MEMORANDUM

REVIEW TYPE: Preliminary Plan of Subdivision

PROJECT NAME: Athey Property

CASE #: 120061160

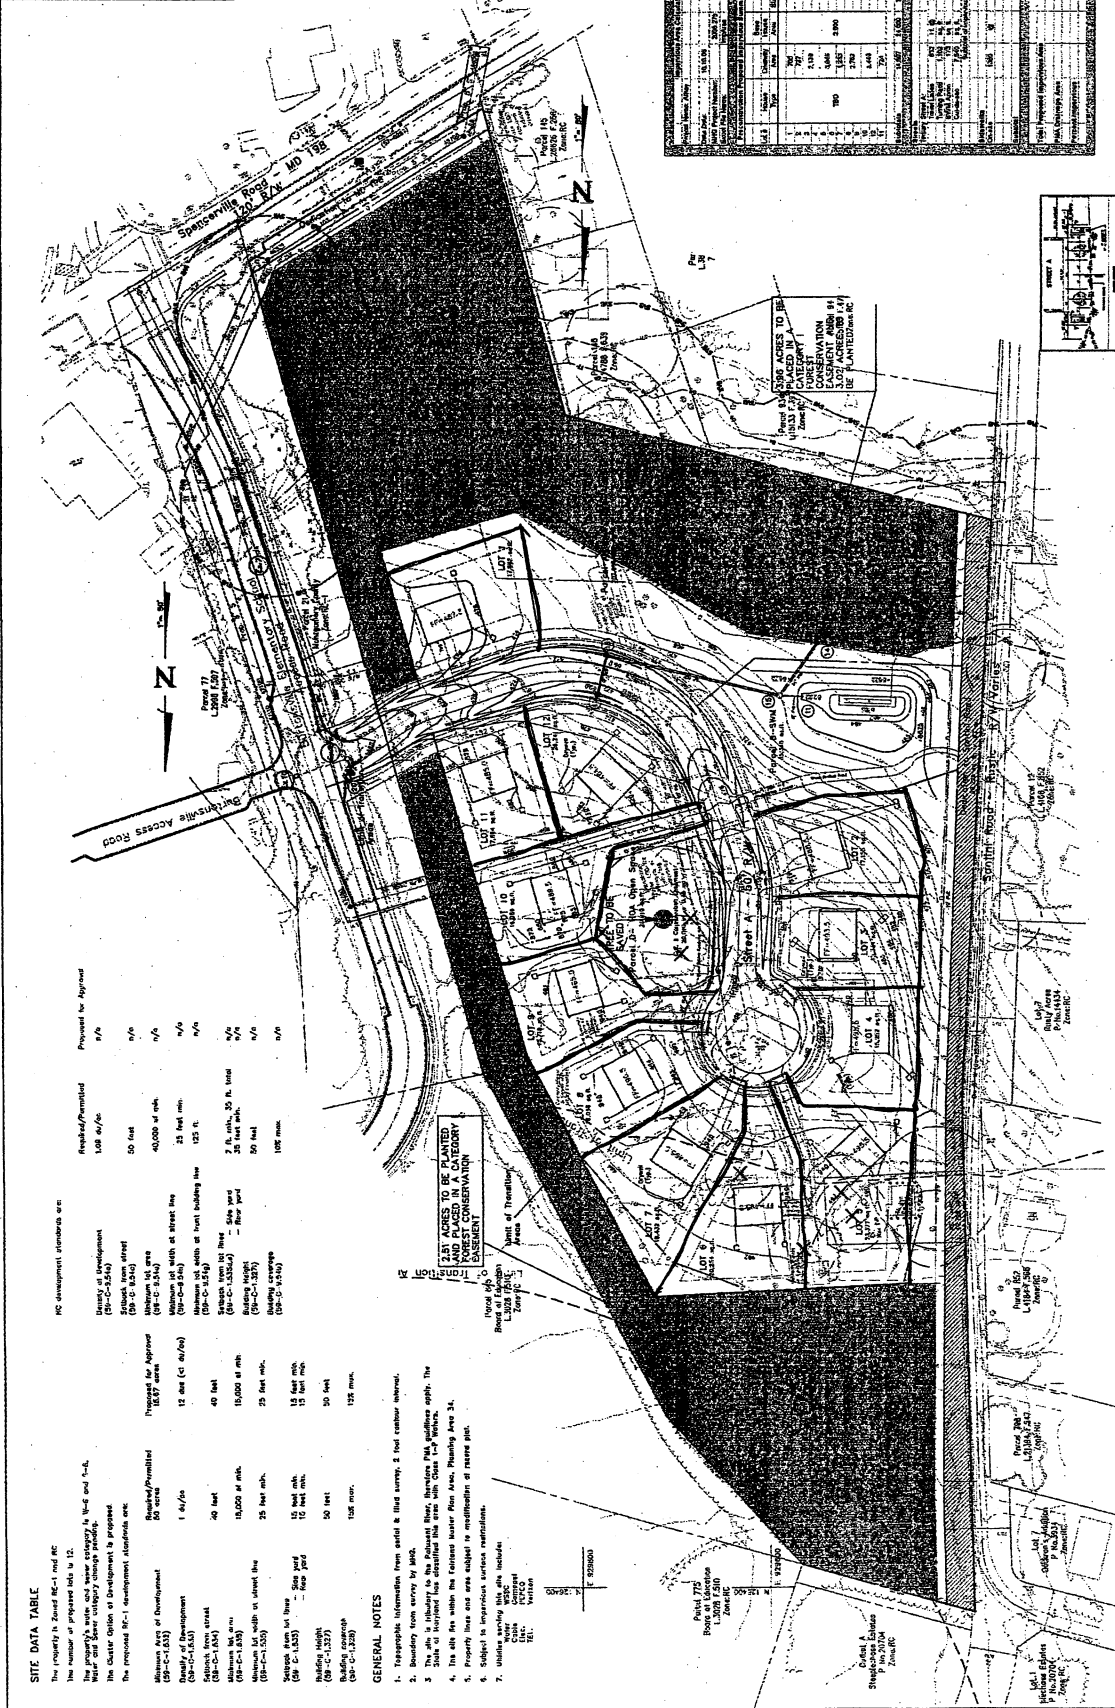
1. Show/label all existing planimetric and topographic details specifically paving, sidewalks and/or bikeways as well as existing rights of way (for surrounding roads including Burtonsville Elementary School Access Road) and easements on the preliminary plan. Also show the location of future Burtonsville Access Road on the preliminary plan.

2. Necessary dedication for Spencerville Road, Santini Road and Burtonsville Elementary School Access Road in accordance with the Master Plan.
 3. Full width dedication and construction of street "A" as an open section tertiary residential roadway terminating in a cul-de-sac. This Road is to be aligned with Burtonsville Access Road.

9. The plan should provide a horizontal alignment for the public street "A" which satisfies the design speed.
10. Prior to approval of the record plat by the Department of Permitting Services, submit a completed, executed and sealed DPWT Sight Distances Evaluation certification form, for Street "A" for our review and approval.

19. In accordance with Section 50-35(n) of the Montgomery County Code, we recommend the Montgomery County Planning Board require the applicant to construct a leadwalk to connect Santini Road and public Street "A" (the preferable location on Santini Road would be at the existing driveway on proposed lot#5).
